Staff Report

RE: Permit Number: 17 02002
Project Name: Settler's Field Preliminary Plat Amendment Minor
Type of Application: Preliminary Plat Amendment Minor

Project Summary:

The applicant has submitted a minor plat amendment to change the interior roads from public to private roads and reduce the number of on-street parking from 45 to 33 spaces.

Site Plan

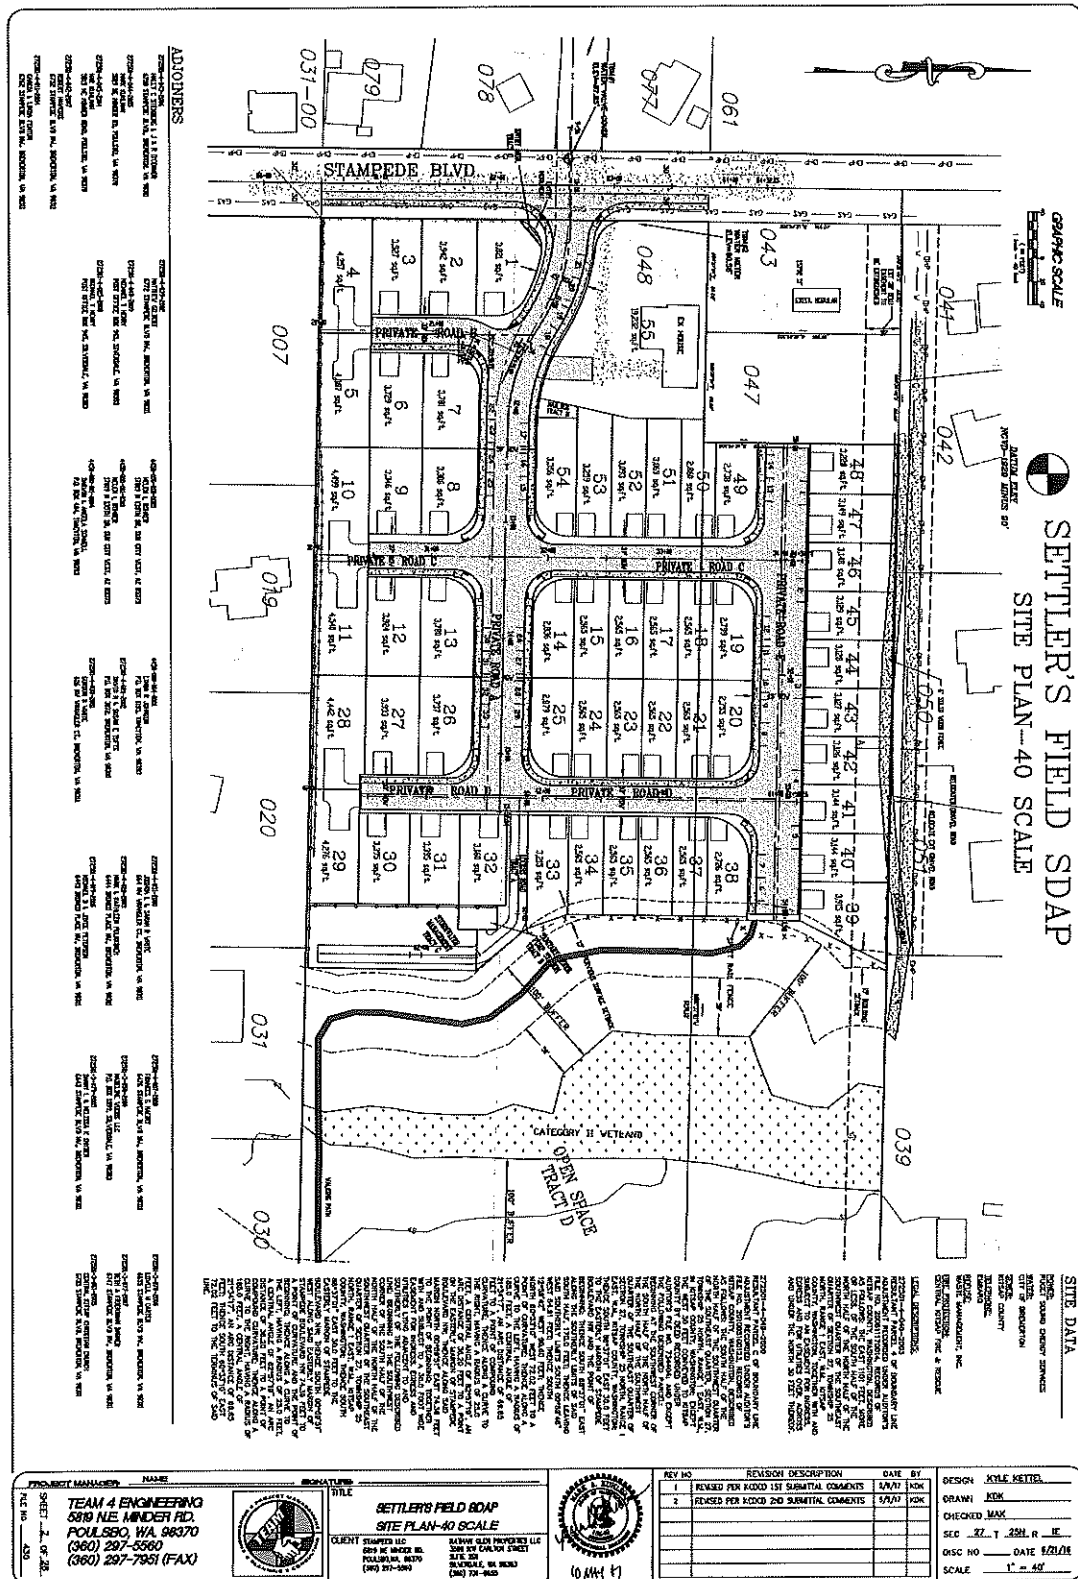
Although there is a reduction in the number of on-street or set-aside parking, the 33 parking spaces exceeds the code requirement of 28 on-street or set-aside parking spaces. Therefore, the on-street or set-aside parking will have no significant impact to the subdivision or surrounding properties.

55. A minimum of 33 on-street parking spaces for plat guests and/or visitors shall be provided as depicted on the site plan.
56. The recreational amenities (sport court, picnic area and trail) shall be maintained and be in good working order by the lot owners within the plat and/or the plat's Home Owner's Association.
